MONTGOMERY COUNTY PLANNING DEPARTMENT
THE MARYLAND-NATIONAL CAPITAL PARK AND PLANNING COMMISSION

MEMORANDUM

REVIEW TYPE: Preliminary Plan of Subdivision

PROJECT NAME: Clement East Property

PRELIMINARY PLAN

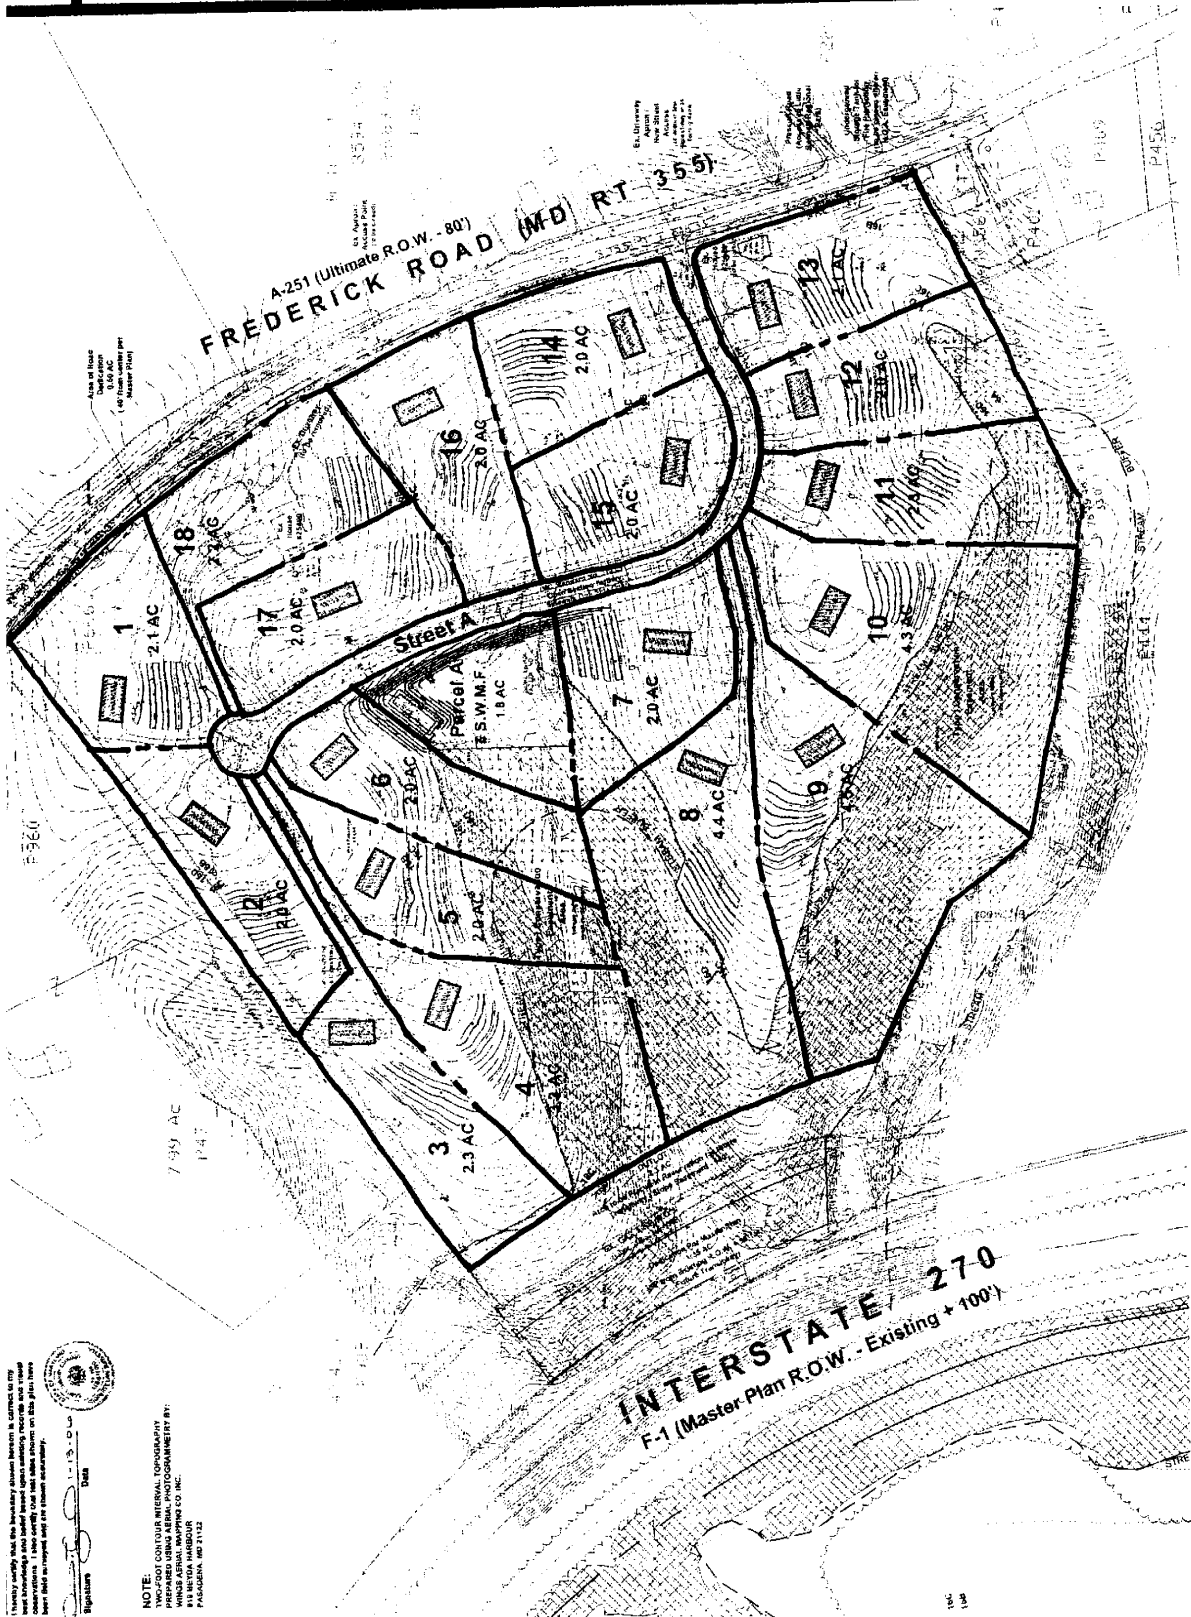
1. Label all existing planimetric and topographic details specifically paving and storm drainage as well as existing rights of way on both sides of the road and easements on the preliminary plan.
2. Necessary dedication for Frederick Road and I-270 in accordance with the master plan.
3. Full width dedication and construction of the interior public street as open section tertiary residential roadway.
4. Grant necessary slope and drainage easements. Slope easements are to be determined by study or set at the building restriction line.
5. Wells and septic systems cannot be located within the right of way nor slope or drainage easements.
6. The plan should provide a horizontal alignment for the interior public street which satisfies the design speed.
7. Record plat to reflect a reciprocal ingress, egress, and public utilities easement to serve the lots accessed by each common driveway.

- The geometry of the proposed street connection with MD 355 must be revised to provide a minimum width of 24' with 30' turning radii.
- The developer/applicant must submit trip generation and trip distribution numbers to SHA for review. SHA should be in a position to determine whether acceleration, deceleration and/or left-turn lanes are warranted after reviewing the requested trip generation numbers.

- An 8' bike/pedestrian path along the MD 355 frontage should be added to the plans according to M-NCPPC requirements.
- Truncations and right-of-way dedications need to be in accordance with the Master Plan of Highways. **Right-of-way dedication along I-270 will also be necessary to facilitate a future transit way.** SHA will require that right-of-way dedications be platted using SHA standards. Please contact Dan Andrews of the Plats and Surveys Division @ 410-545-8975 for additional information. You may also e-mail Mr. Andrews at dandrews@sha.state.md.us.
